D/DRC Case

2303 Park Street

Elmwood Park Architectural Conservation District

DESIGN/DEVELOPMENT REVIEW COMMISSION
DESIGN REVIEW DISTRICT
HISTORIC AGENDA
EVALUATION SHEET
Case #2

Left corner

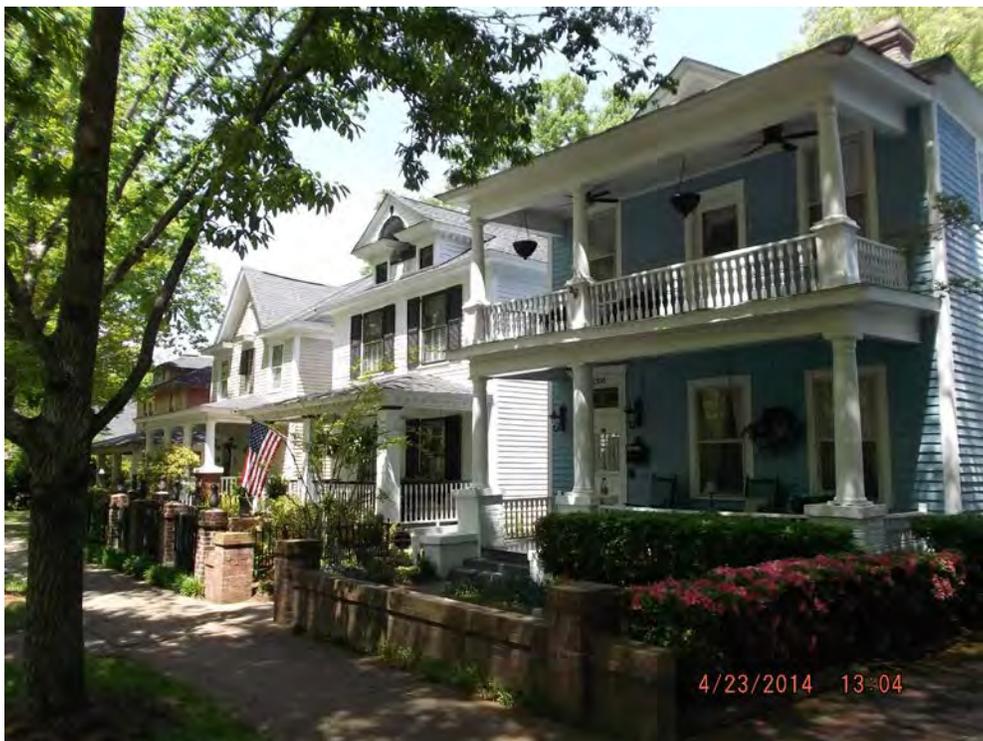
This is a request to add front porch railings to the ca. 1910 two-story wood-sided house located at 2303 Park Street in the Elmwood Park Architectural Conservation District. This house is a contributing structure in the local historic district as well as in the Elmwood Park National Register of Historic Places district. The house does not currently feature a balustrade or any type of porch railings, and it appears that it has been this way for some time. Staff located a photograph of the house from 1968 that shows very crude rails with no balusters, which were obviously not original. The front porch columns have been replaced, so staff was unable to inspect for evidence of an original balustrade.

The applicant has not provided any documentary, physical, or pictorial evidence to substantiate that a front porch balustrade ever existed at this property. There are, however, similar houses in the district that currently feature balustrades. In fact, there are more houses with porch railings than without in the block on which 2303 Park Street is located. Staff contends that installing a historically correct balustrade would add architectural character and make the porch safer.

- A new wood balustrade with turned balusters shall be installed to visually match historic examples found on similar houses within the district.
- All new wood features shall feature a painted finish
- All details deferred to staff including any additional work required to meet code
